KPA500 KIT ASSEMBLY MANUAL ERRATA

Rev. F6-4, January 9, 2017

E740149E

Figure 34. Connecting the 270V Wire to the PA/LPF Module.

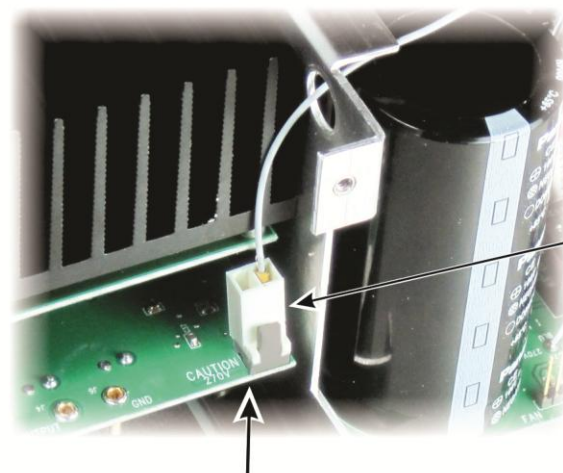
1. Page 25, replace the last check box step and Figure 34 with the following:

Connect the 270V wire from the power supply module to the PA/LPF module as shown in Figure 34. **Support the pc board so it does not flex while mating the connector.** This is the connector you routed through the hole in the Z-bracket earlier.

ORIENT CONNECTOR
AS SHOWN (COLORS
ENHANCED FOR
CLARITY)

CAUTION

SUPPORT THE BOARD FROM BELOW WITH YOUR FINGERS
WHILE ATTACHING THE CONNECTOR SO THE BOARD CANNOT FLEX.
ALLOWING THE BOARD TO FLEX MAY BREAK COMPONENTS ON THE BOARD.

Figure 47. Installing the Bottom Rubber Disks.

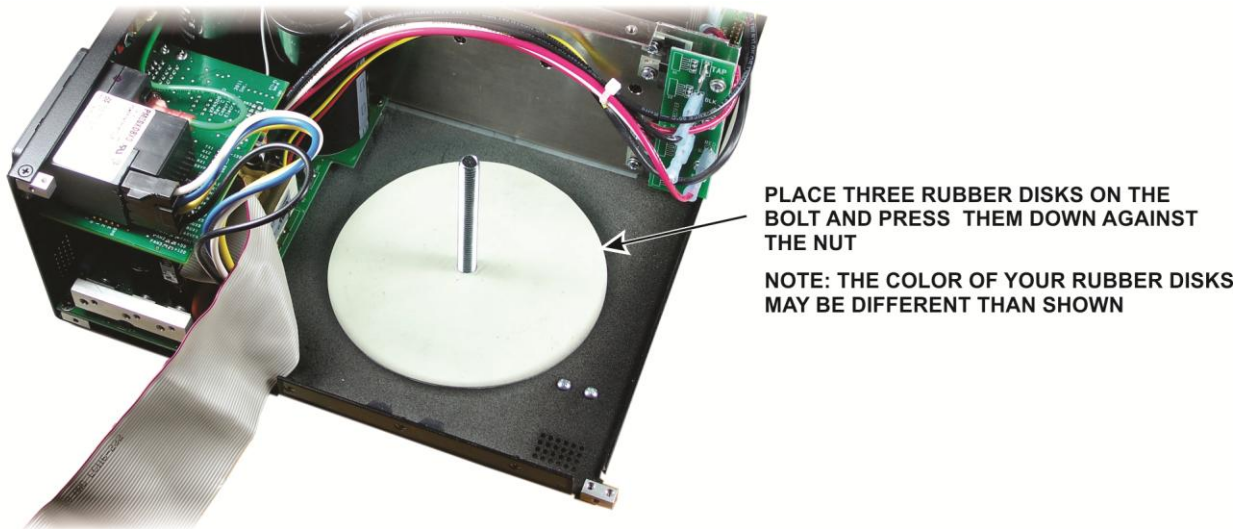
2. Page 32, replace the last checkbox step and Figure 47 with the following:

- Place three rubber disks on the bolt and move them down against the bottom cover. The nut and washers will be under the disk as shown in Figure 47.
